Countries: CANADA, UNITED STATES Document ID: IK1201440
 Availability: ISIS, FleetISIS, IsSIR Revision: 3
 Major System: ENGINES Created: 8/25/2019
 Current Language: English Last Modified: 6/16/2022
 Other Languages: NONE Author: Greg Scheff
 Viewed: 863

Title: A26 Fuel Delivery Pressure Sensor (FDP) and Harness Pigtail Eliminated

Applies To: All A26 Engines

Figure #1: Engine Mounted Fuel Filter Housing

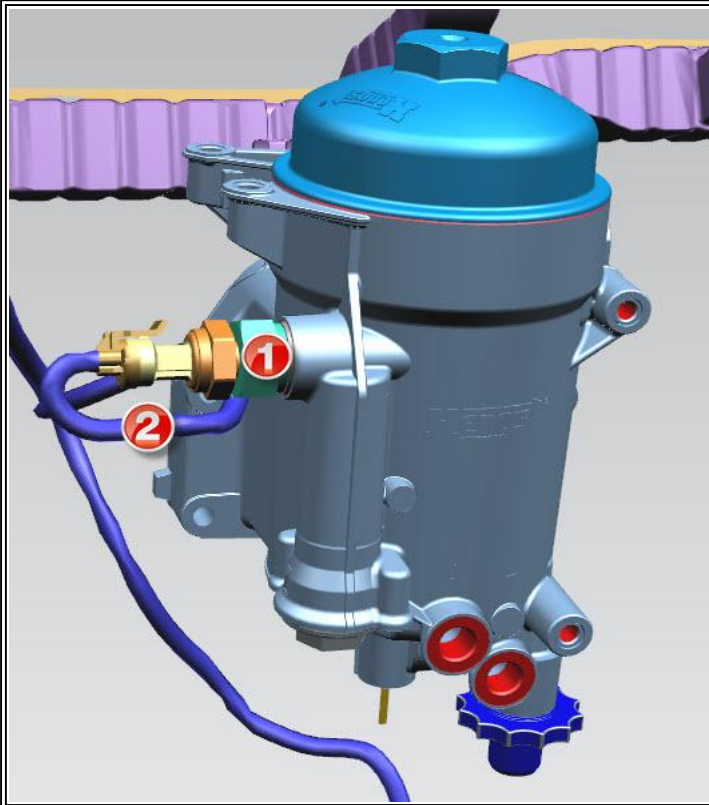
This document will explain the removal of the fuel delivery pressure sensor and harness pigtail on the A26 engine. The early built A26 engines had the fuel delivery pressure sensor installed in the engine mounted fuel filter housing (Figure #1) however, the ECM never monitored the signal from it. Later the sensor was removed, the port was plugged, and the engine harness was modified to remove the pigtail and the connector for it.

Questions from the field have come up while installing a replacement engine harness. Some of the C92 engine harnesses may come through parts when you are replacing a harness on an engine that does not have a FDP sensor installed.

IT IS ACCEPTABLE to install a C92 harness on a newer engine not equipped with the FDP sensor.

- The unused pigtail (Figure #1 item 2) and connector for the FDP sensor can simply be tied off and tucked out of the way OR
- The pigtail (Figure #1 item 2) can be cut off, and apply heat shrink tubing at the wire ends
- The wiring for those circuits to the ECM are not used
